# Site Visit Report

<b>Project Title</b>	Murgatroyd's Brine Pump Emergency Works	<b>Project No</b>	8402
<b>Client</b>	Middlewich Heritage Trust	<b>Date</b>	08.01.20
<b>Purpose</b>	Site Progress and Observations	<b>Visit By</b>	EG

Figure 6 *Gap and Window discussed*

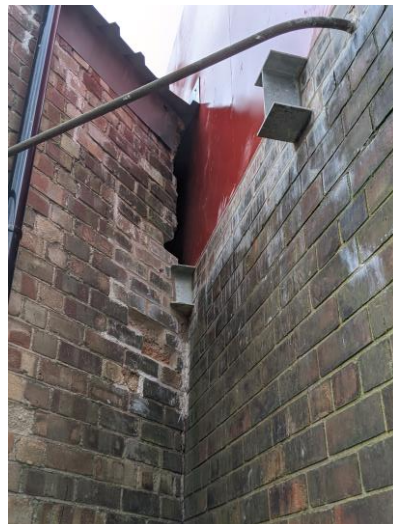
**Figure 6 Brick gap and window replacement discussed with client**

Quadriga to include for a cost to replace this window, both like for like and a hard wood version. Buttress to liaise with HE regarding the replacement. Buttress to instruct how the gap will be resolved once window/lintel scope is established.
